28 March 2016

In re: Sunoco Mariner East 2 Pipeline Project

Summary and Recommendations

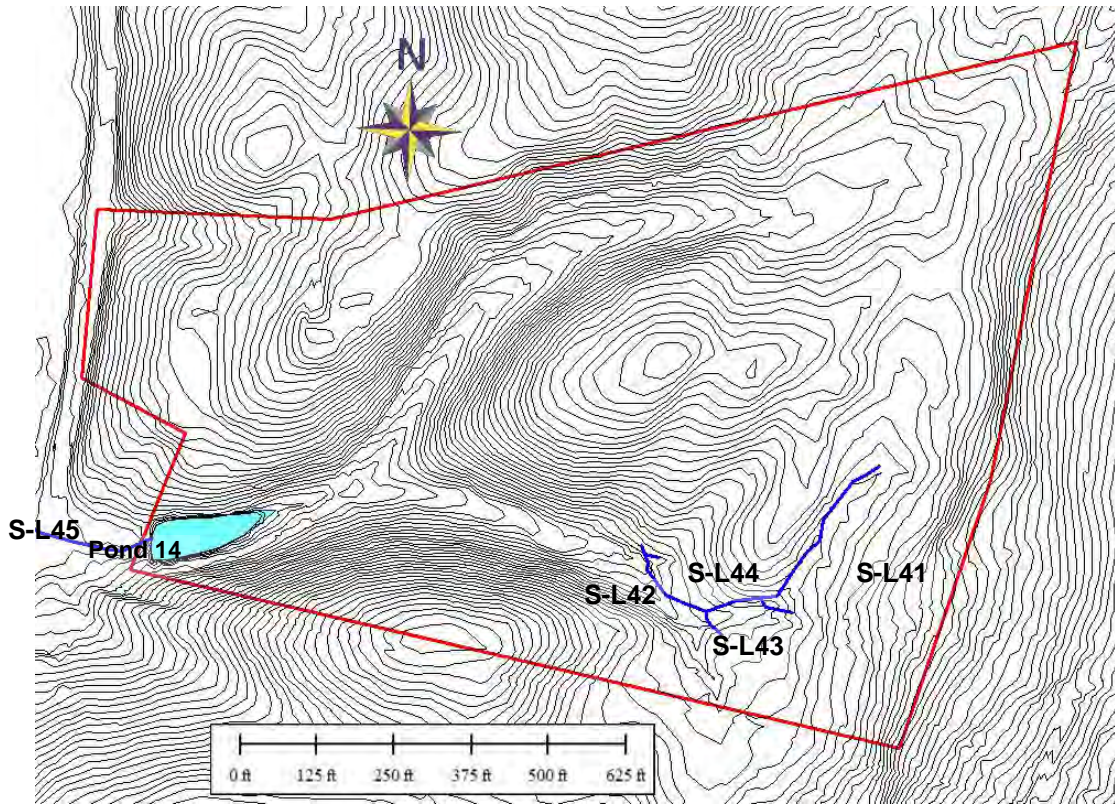
As listed above, the pipeline drawings identify five stream segments on this property (Figure 3, top), all of which are identified as being intermittent except for Stream S-L43, which is identified as ephemeral. These onsite waterways are shown as disconnected

segments rather than as a single linked aquatic system. Together, the five pipeline-identified stream segments extend 706 linear feet. S-L41 and S-L42 are segments of the same watercourse (which we call the southern stream). The pipeline drawing also shows a short tributary to S-L 41, which is not otherwise identified. This small, unlabeled feature had no flow on 17 March, and we judged it to be ephemeral. All the other watercourses identified by the pipeline drawing had flowing water on 17 March. Absent any visible stormwater runoff or recent precipitation, their only source was groundwater discharge at the time of our inspection.

In fact, there are two main bed-and-bank watercourses on the subject property that feed your pond, plus at least one smaller connected tributary drainageway (Figure 3, bottom). The two main streams can be described as relatively permanent, inasmuch as they have prolonged flow of groundwater and a diverse streambed community of benthic invertebrate organisms. The two main streams converge within wetlands about 100 feet upslope from your pond. As noted in State technical guidance, ponds in Pennsylvania generally constitute evidence that their tributary streams have permanent flow. State regulations apply equally to permanent and intermittent streams. West of the pond a single stream flows through a culvert beneath Trough Creek Valley Pike and converges with Little Trough Creek within a large wetland downstream from your land. Your northern onsite stream is of less concern at present because it is largely remote from currently-proposed pipeline activities. We do not focus on it here. The pipeline-designated S-L41 and S-L42 are upstream segments of the southern stream that feeds your pond. The northern stream is not shown on the pipeline drawing at all, even though its confluence with the southern stream lies immediately outside the edge of the ATWS rectangle shown on the pipeline drawing.

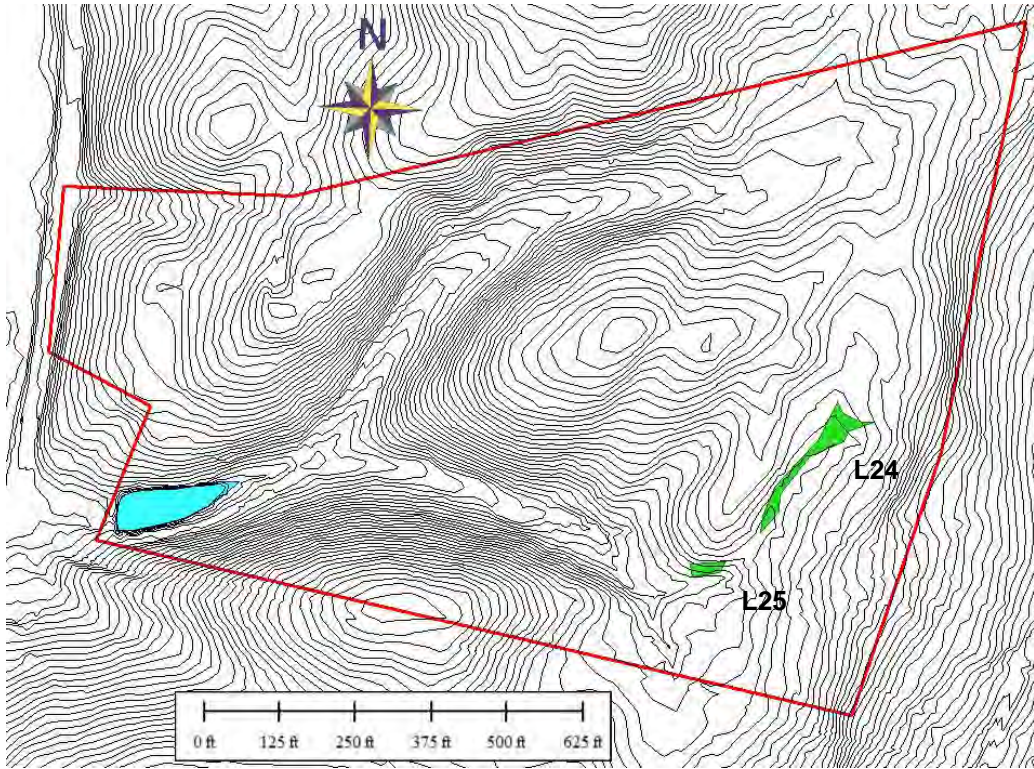
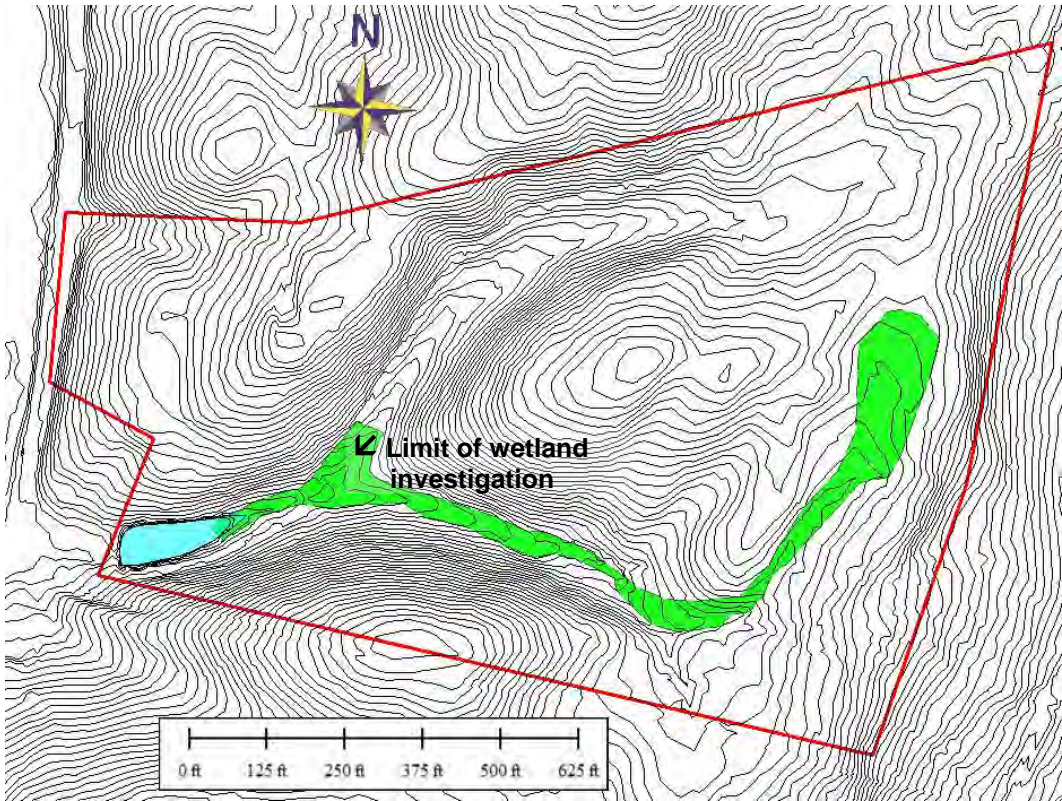
The wetlands on your property are significantly more extensive than shown on the pipeline consultant's inaccurate drawings. This conclusion is supported by Huntingdon County soil survey mapping, State topographic mapping, and our own on-site field investigation focused on the southern section of the property in the vicinity of the proposed pipeline route. We identified wetlands on the basis of field evidence of hydrophytic plants, hydric soils, and soil saturation in accordance with the 1987 Wetlands Delineation Manual and the Eastern Mountains and Piedmont Regional Supplement (Environmental Laboratory 1987, US Army Corps of Engineers 2012).

As discussed below, Wetlands L24 and L25 are in fact much larger than shown on the pipeline drawing and extend well into the surrounding forest at a distance from the stream bank. The consequence of mischaracterizing the nature of Wetland L24 (L25 was not identified as within the proposed limit of disturbance [LOD]) is that any proposed clearing and permanent maintenance of the right of way (ROW) will result in conversion of this forested wetland to emergent herbaceous vegetation, an adverse impact, even if the reestablishment of wetland hydrology and soil is successful here. The nearby offsite wetland (L26) was not examined closely in the field by us, and it may be correctly identified

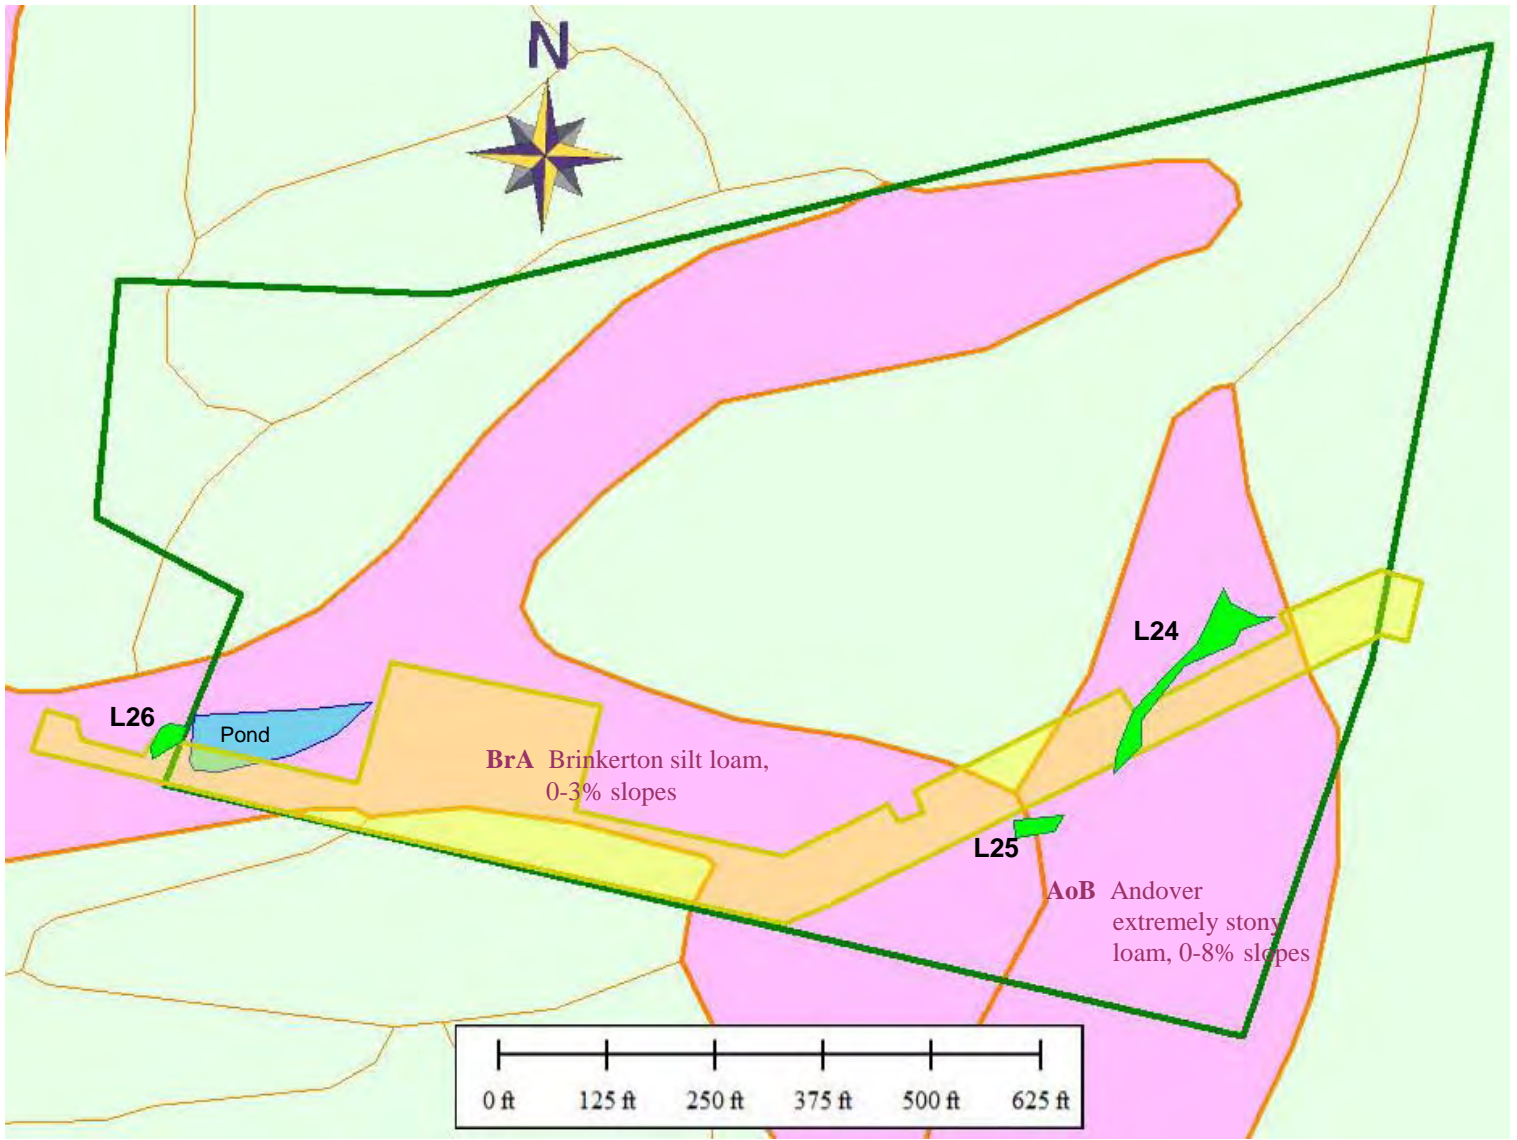
According to the county soil survey, poorly drained hydric soils are mapped in the flatter areas of the property primarily along the two major streams (see Figure 5). Hydric soil map units mapped on this property include Brinkerton silt loam, 0-3% slopes (BrA) and Andover extremely stony loam, 0-8% slopes (AoB), which map units together cover 12.6 acres (46%) of the subject property (Figure 6). Pipeline consultant-delineated wetlands L24 and L25 are within the mapped Andover soils, and the pond encompasses 0.22 acre within the mapped Brinkerton soils. Actual hydric soils, as we encountered in the field and sketched on Figure 7 (bottom) are somewhat less extensive than county soil survey map polygons suggest, but are significantly more extensive along the watercourses than the tiny wetlands mapped on the pipeline drawing (Figure 7, top). Finding the precise limits of the hydric soils in the field here is a laborious and time-consuming task as a result of the abundant stones that render augering a challenge. In particular, wetland conditions extend well upslope beyond the upper end of pipeline consultant-delineated wetland L24 (Photos 3 and 4). We left pink flags around the wetlands in this upper section of the southern watercourse. Our flagging was conservative, and we may not have included all the actual wetlands.

Photo 1. View northward from the Buckeye Pipeline ROW into the upper section of an unnamed tributary incorrectly mapped by Sunoco consultant as ephemeral (S-L43). Water within the defined bed and banks can be seen here near where it meets the existing ROW.

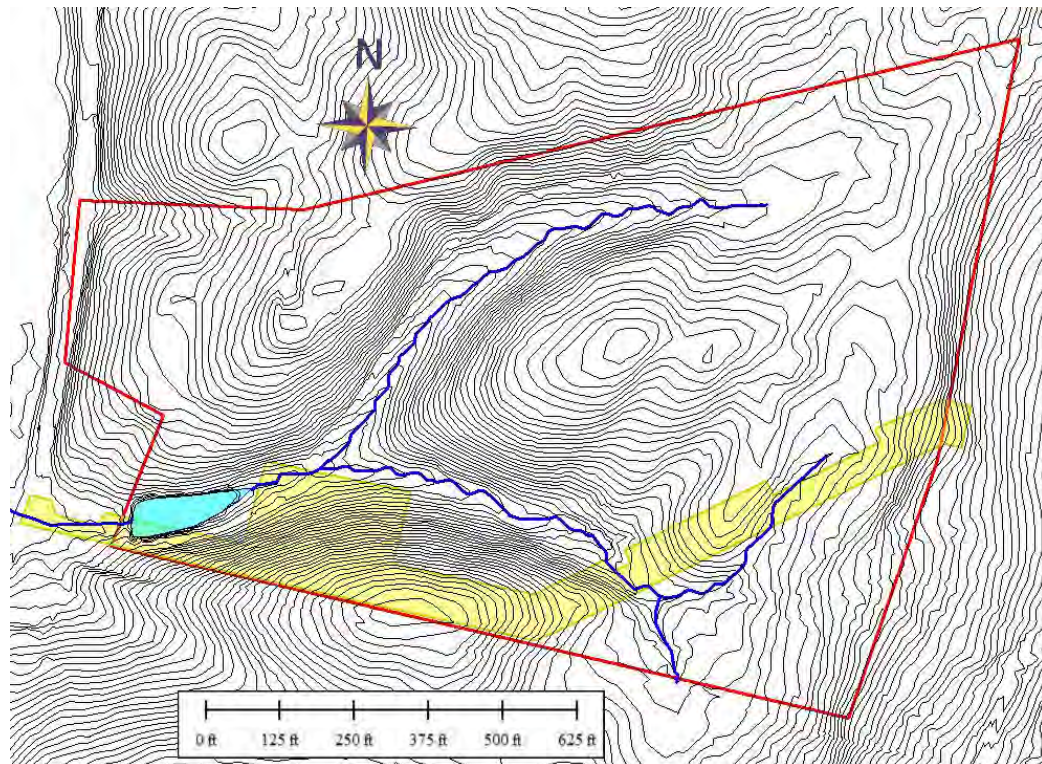
The onsite streams as depicted by us at the bottom of Figure 3 are taken from the PADCNr LiDAR-based topographic mapping¹ of drainageways for this area. During Schmid & Company field investigations on 17 March 2016 Mr. Kunz and I confirmed the general accuracy of the LiDAR topographic and streamcourse mapping. We added one short tributary which arises as a bed-and-banks feature in the existing Buckeye pipeline ROW along the south side of the property. A very short segment of this same waterway is identified by the pipeline consultant and labeled Stream S-L43. The pipeline mapping of this waterway is deficient in two respects: (1) it does not show the full extent of the intermittent channel on your property, and (2) it describes this stream as ephemeral. On the day of our field inspection, we observed this waterway to have an established bed and banks, as well as water within or just below the streambed, from its connection with the southern main onsite watercourse up to and into the existing Buckeye pipeline ROW (Photos 1 and 2). This flow originated from groundwater, not from surface runoff.
